# MIAMI BEACH

PLANNING DEPARTMENT  
Staff Report & Recommendation

SUBJECT: DRB21-0657  
**2145 North Meridian Avenue**

An application has been filed requesting Design Review Approval for the construction of a new two-story single-family home that includes a variance from the minimum required lot size, to replace an existing architecturally significant pre-1942 home.

Lot 24, Block 1 Original Plat of February 6, 1920.

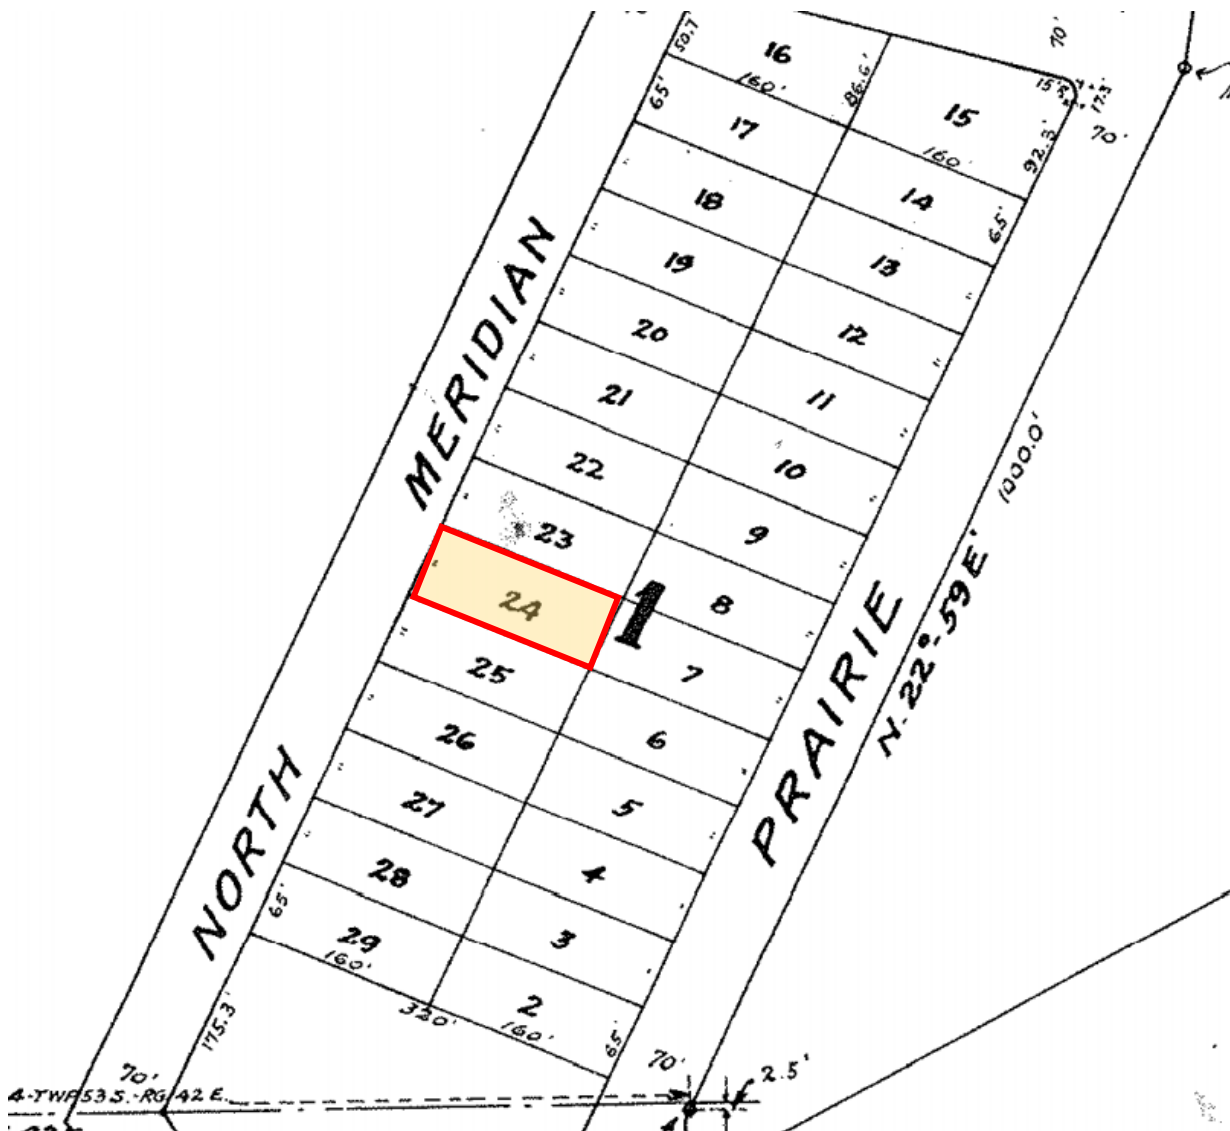
The subject property is a mid-block parcel, adjacent to the Miami beach Golf Course, and originally platted as Lot 24 on Block 1, of the Mid-Golf subdivision of Miami Beach Shore Company which was historically platted on February 6, 1920 with standard lots measuring 65'-0" wide by 160 feet deep. At some time in the past, 5'-0" of the north side of the property was transferred to lot 23 on the north side of the parcel.

Today the lot is 60 feet wide and 160 feet deep and contains a lot area of approximately 9,587 SF. The RS-3 zoning district requires lots to have a minimum lot area of 10,000 SF in order to be a developable parcel and a variance is being requested to develop a site that is less than 10,000 square feet.

Section 118-390 of the City Code, pertaining to nonconformances, provides that "legally established" means a lot that does not meet the lot frontage, lot width, lot depth, and/or lot area requirements of the current zoning district, provided that such lot met the regulations in effect at the time of platting. While this property is part of lot 24 of Block 1 of the original 1920 plat of Mid-Golf subdivision of Miami Beach Shore Company, the site was originally platted with a lot width of 65'-0" and approximately 10,400 sf of area, similar to the adjacent properties.

It is not clear when the property was reduced in width to 60'-0" and that portion was transferred to the adjacent lot 23 on the north side. The applicant has provided a property deed dating from 1972 showing the property width of 60'-0". Staff would also note that current records of Miami-Dade County note this property with a width of 60'-0". Based on the evidence provided and staff research, it appears that the current size of the lot has been established for a very

long time. Without the granting of this variance, the construction of a new residence, or any structure for that matter, would not be permitted on the property and the site could not be developed as other lots in the same district. Staff finds that the size of the lot, as it exists today, creates the hardship that justifies the variance request and recommends approval of the variance.
